WM. H. ZIMMER POWER STATIONINSTRUCTIONS FOR UPDATING YOUR  
DESIGN ASSESSMENT REPORT

Changes to the MARK II DAR are identified by a vertical line in the right margin of the page. To update your copy of the ZPS-1 DAR, remove and destroy the following pages and figures and insert pages and figures as indicated.

AMENDMENT 15  
MAY 1981

MARK II DESIGN ASSESSMENT REPORT

FIGURE 5.3-28

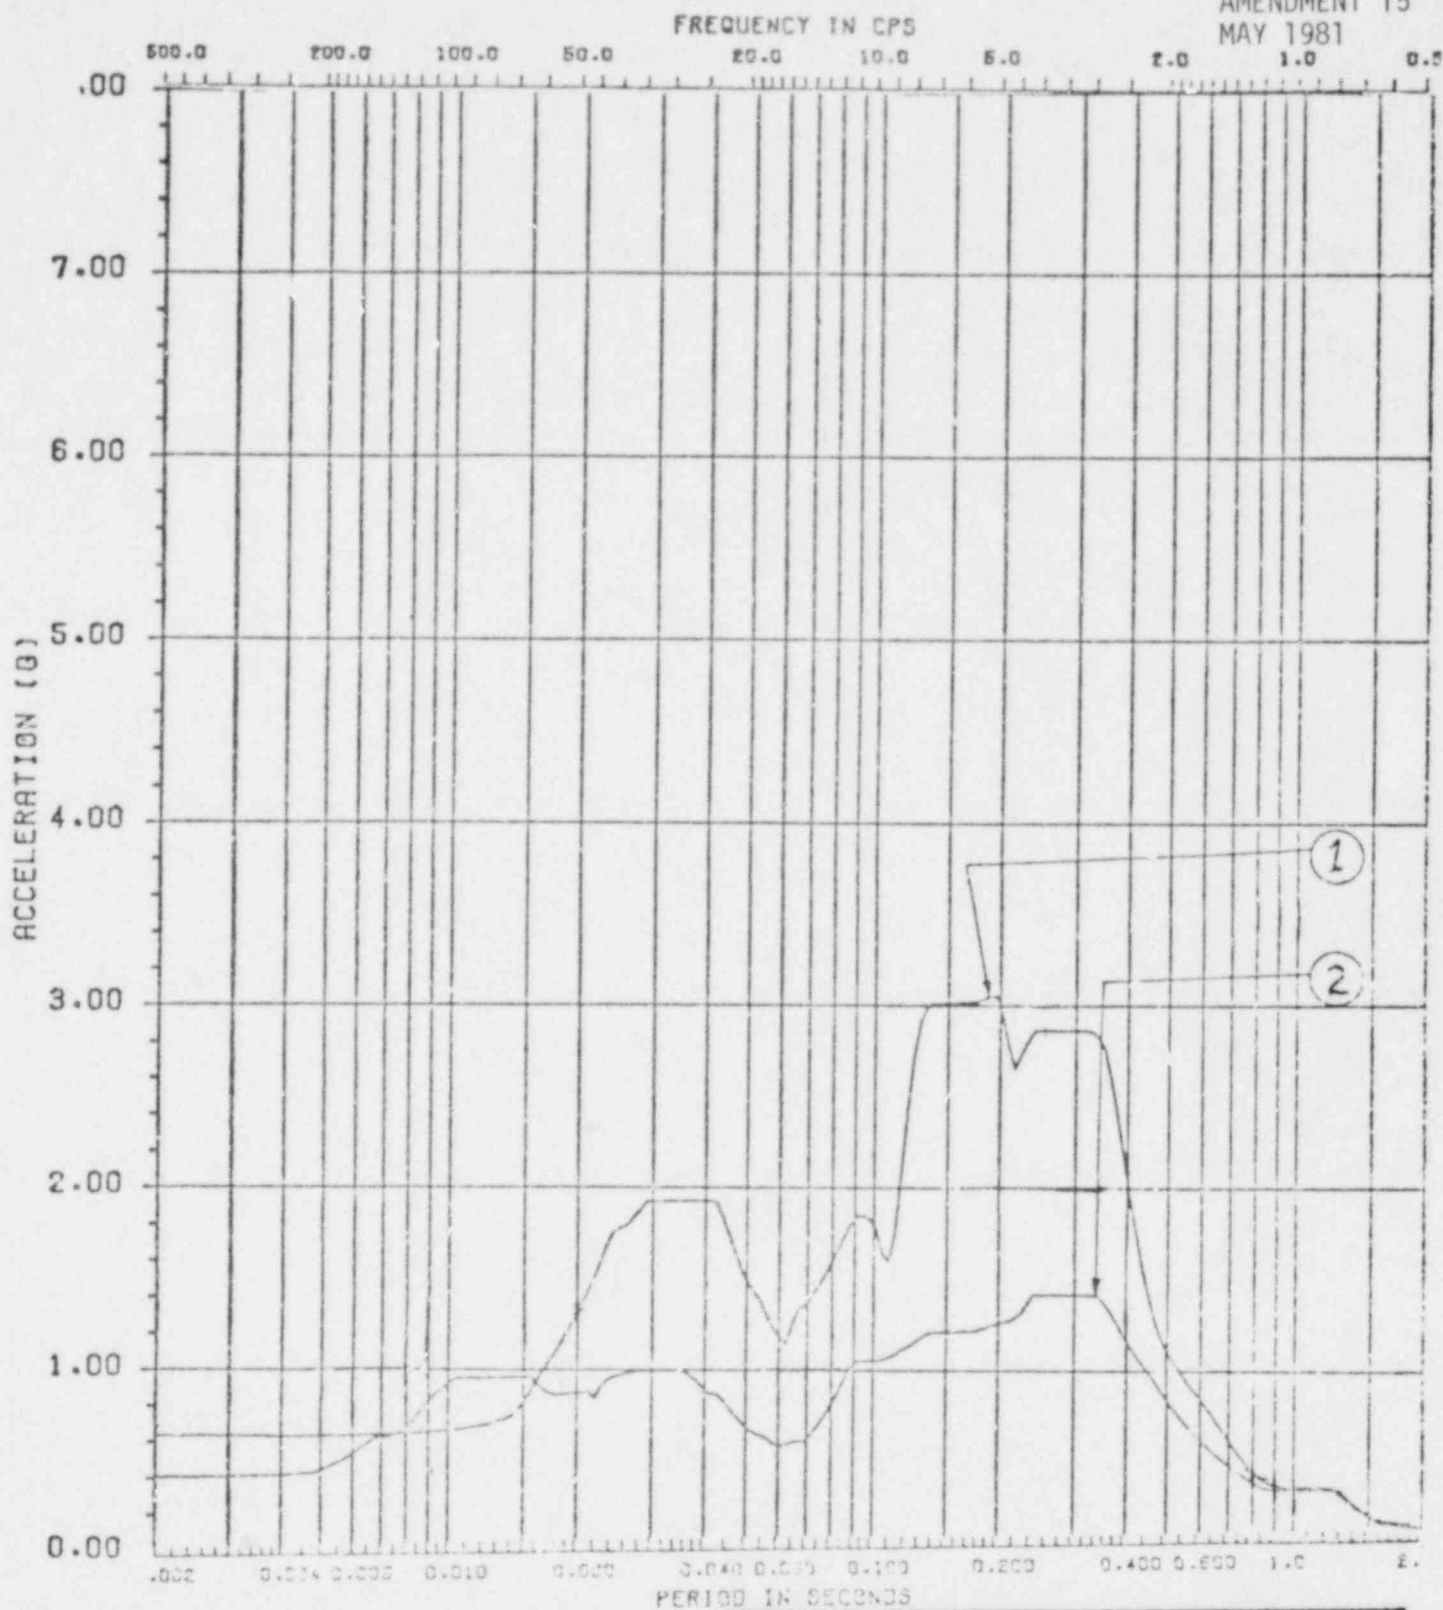
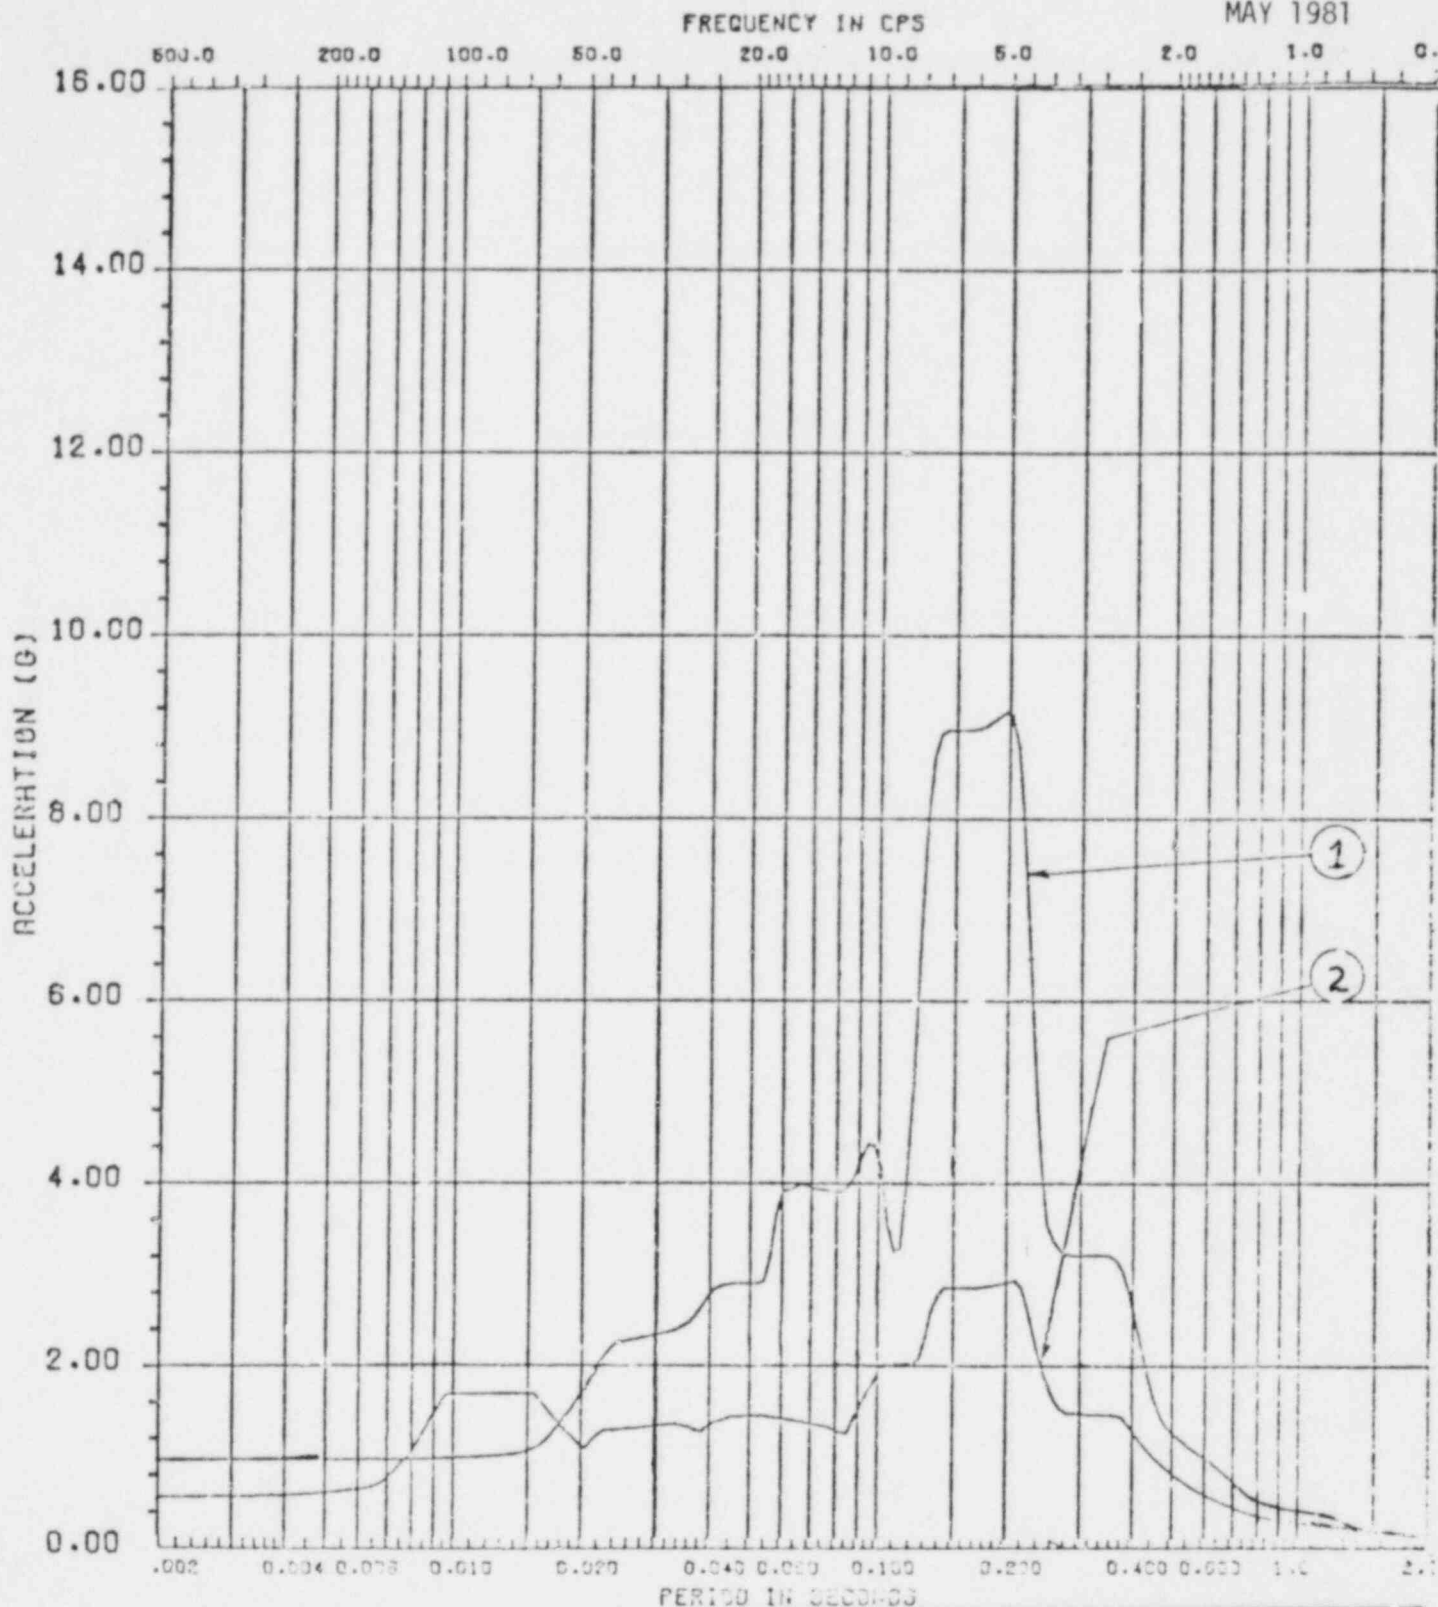
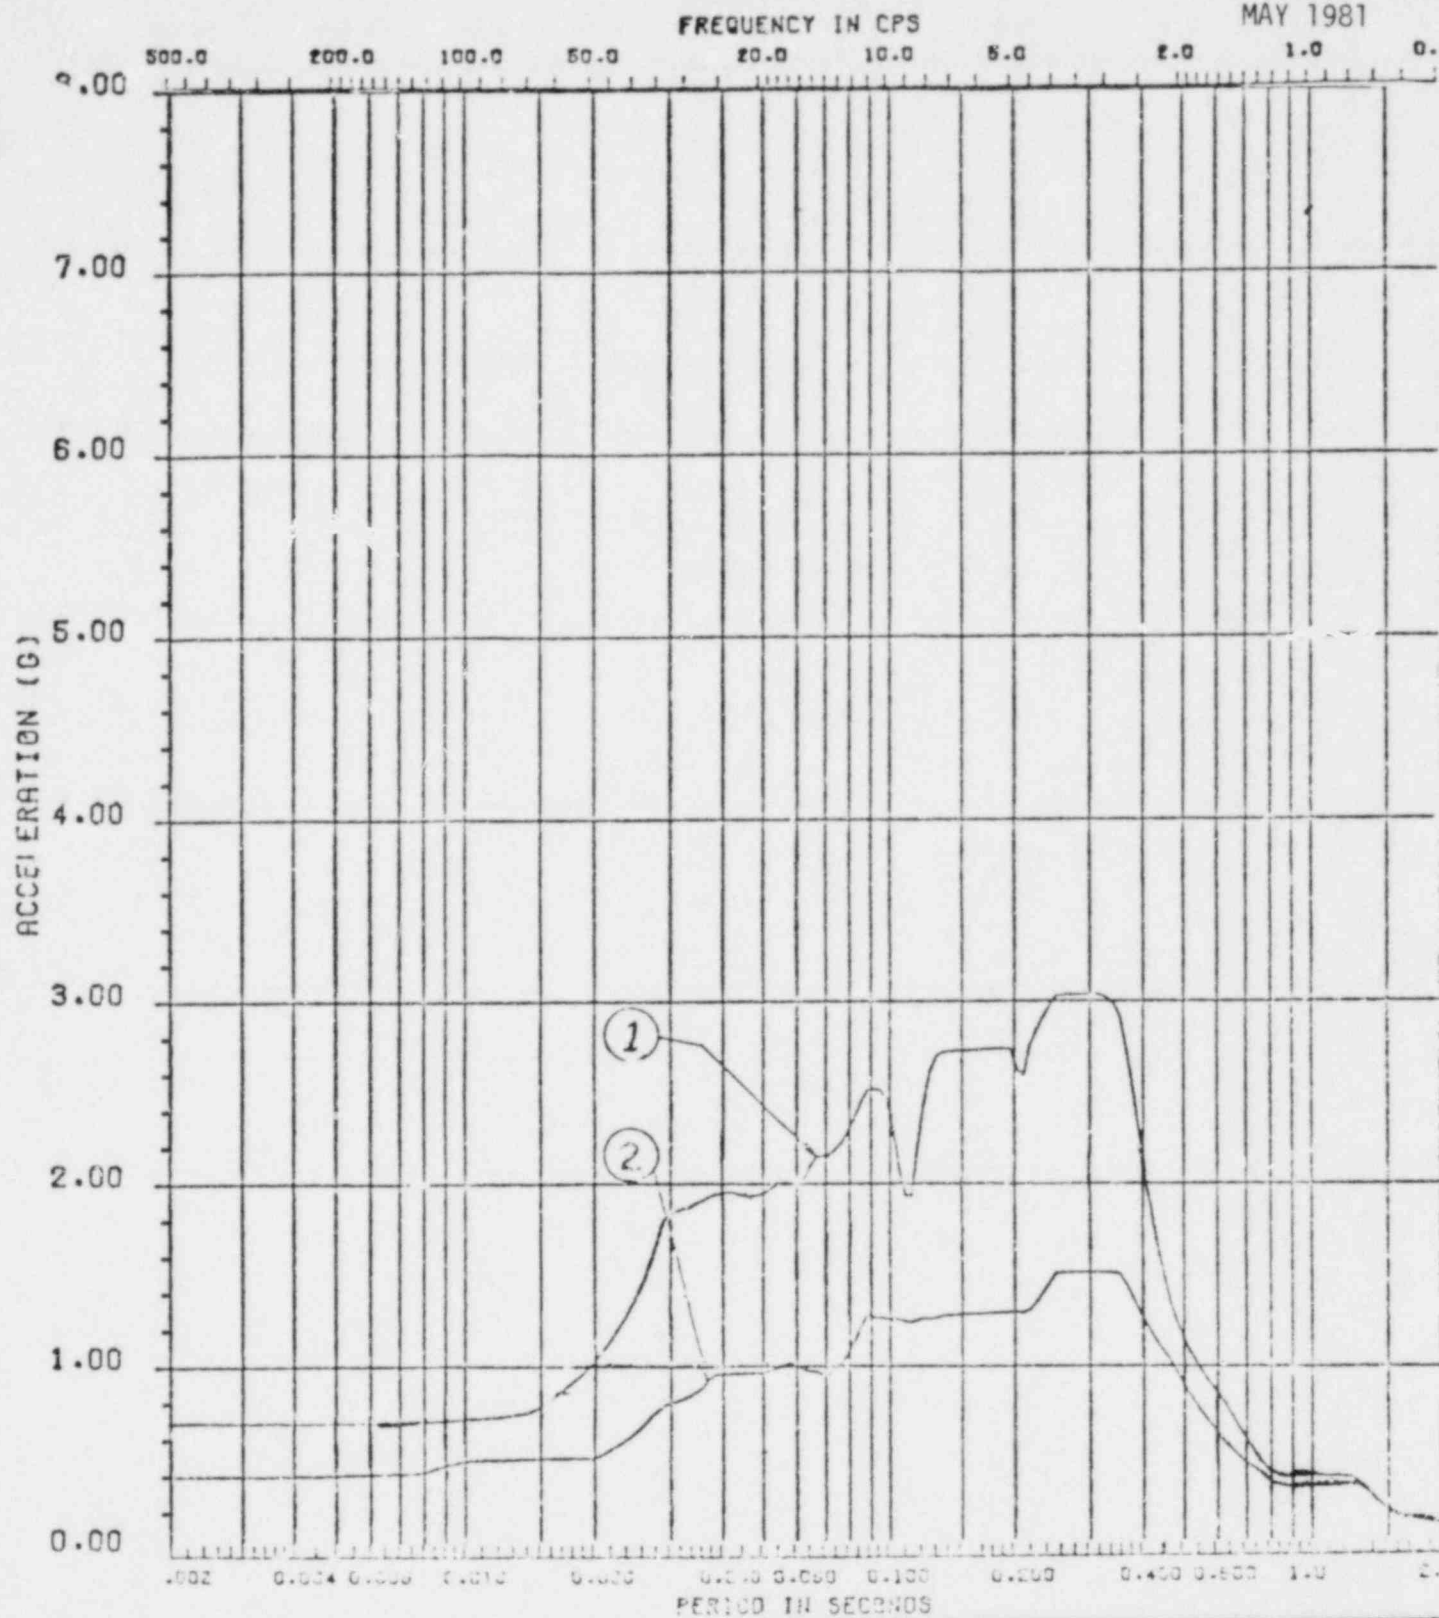
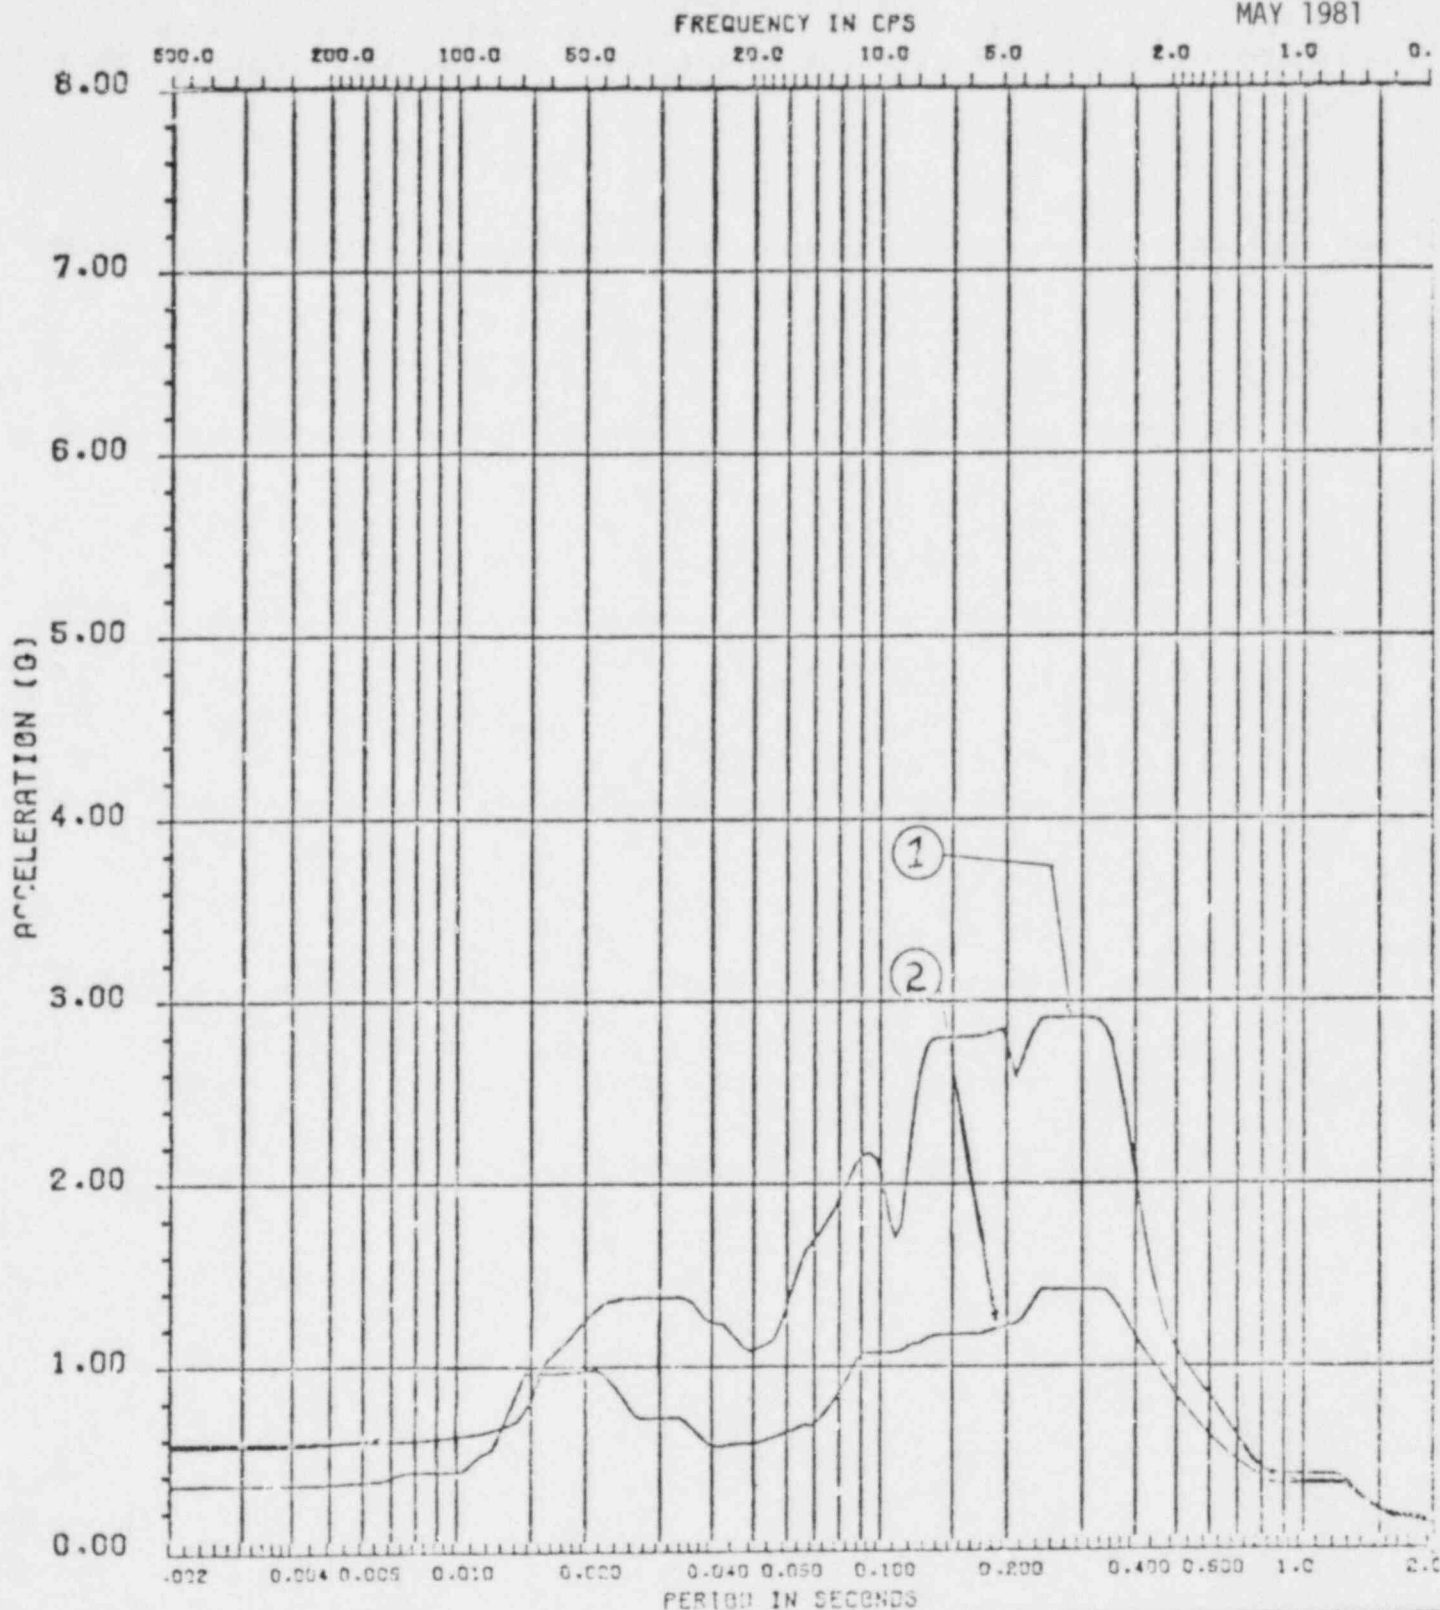
Comparison of typical response spectra envelopes are included here. The two curves represent the Zimmer design basis and a hypothetical design basis utilizing 4TCO data and the SRSS (Square Root of the Sum of the Squares) method of load combinations which has been approved by the NRC for Mark II application.

Curve 1 represents an envelope of the Zimmer Empirical Load (ZEL) Design Basis:

Curve 2 represents an envelope of loads based on 4TCO data combined with seismic and SRV loads:

Each load combination is combined by SRSS. Although a reduction in the SRV (ADS) amplitude multiplier of about 30% (1.1 in place of 1.5) has been approved by NRC, this reduction was not included in this comparison.

These comparisons show that the design basis is very conservative at frequencies below 50 hertz. The occasional exceedences above 50 hertz are not considered significant to the design.
